RE: Engel Errata & Declaration

Page 4 (modifying Table 10.1 and Figure 10.1);
Page 45 (modifying Appendix Figure 15);
Page 47 (modifying Appendix Figure 18); and
Page 48 (modifying Appendix Table 12).

10. Hydrologic/Water Quality (GLEAMS) Modeling of Illinois River Watershed

Figure 10.1. Relationship between Observed P Load and Predicted P Load to Lake Tenkiller for 1997-2006

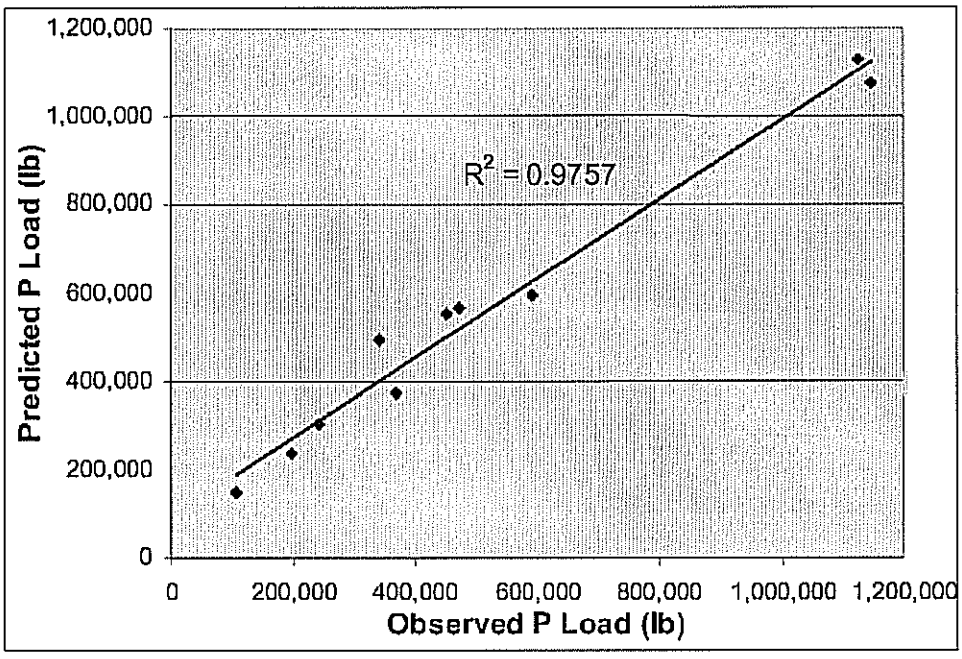
I have spoken with Dr. Engel and what he stated in his Declaration is correct – the observed phosphorus loads for the gauging stations did not change. As you correctly point out, however, Table 10.1 in the Engel Errata has different numbers for the "Observed Total P Load (lb)" column for the years 1998-2006 than as originally stated in Table 10.1 of Engel's original Report. Consistent with his Declaration the "Observed Total P Load" numbers in Table 10-1 of Engel's Errata should have remained the same as the numbers the original Report. The confusion occurred because the 1998-2006 Observed Total P Load numbers in Table 10.1 of the Engel Errata were stated incorrectly. Because of this error, Errata Table 10.1 contained the wrong Observed Total P Load numbers for 1998 – 2006; it should have stated the same numbers as were set out in the original Report. As a consequence, Table 10.1 of the Errata and Figure 10.1 of the Errata (which is also on page 4 of the Errata) were created with the wrong Observed Total P Load data. Due to this same error the "Appendix D" Errata for Figure 15 (Errata p. 45), Figure 18 (Errata p. 47), and Table 12 (Errata p. 48) also need to be modified because of the mistake.
